SUBJECT: PRELIMINARY CERTIFICATE OF COMPLIANCE AND SAFETY EVALUATION
REPORT FOR THE NUHOMS® STORAGE SYSTEM (TAC NO. L22954)

By letter dated July 26, 1999, as supplemented, Transnuclear West Inc. (TN West) submitted an application to the Nuclear Regulatory Commission, in accordance with 10 CFR Part 72, for the review and approval of Amendment 3 to the NUHOMS® Certificate of Compliance No. 1004.

Certificate No. 1004 -
Amendment 3

ATTACHMENT A
TECHNICAL SPECIFICATIONS

Figure 10-3-1
PWR Fuel Criticality Acceptance Curve

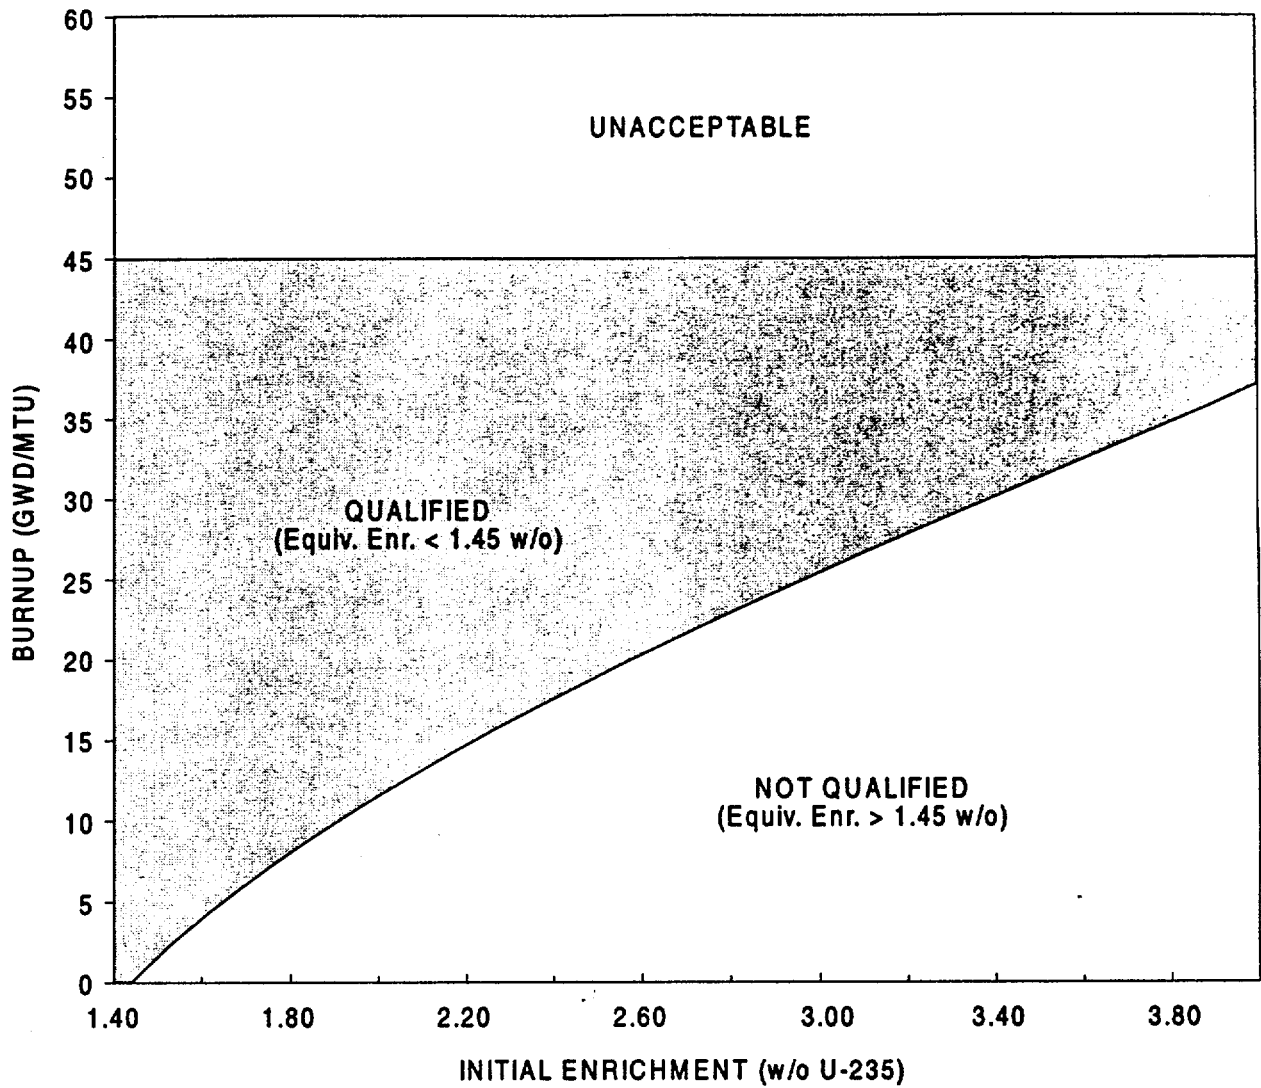
- Limit/Specification:** The characteristics of the spent fuel which is allowed to be stored in the standardized NUHOMS[®] system are limited by those included in Tables 10.3-1 and 10.3-2, and Figure 10.3-1.

- Action:** Each spent fuel assembly to be loaded into a DSC shall have the parameters listed in Table 10.3-1 and Figure 10.3-1 for PWR fuel, or Table 10.3-2 for BWR fuel verified and documented. Fuel not meeting this specification shall not be stored in the standardized NUHOMS[®] system.
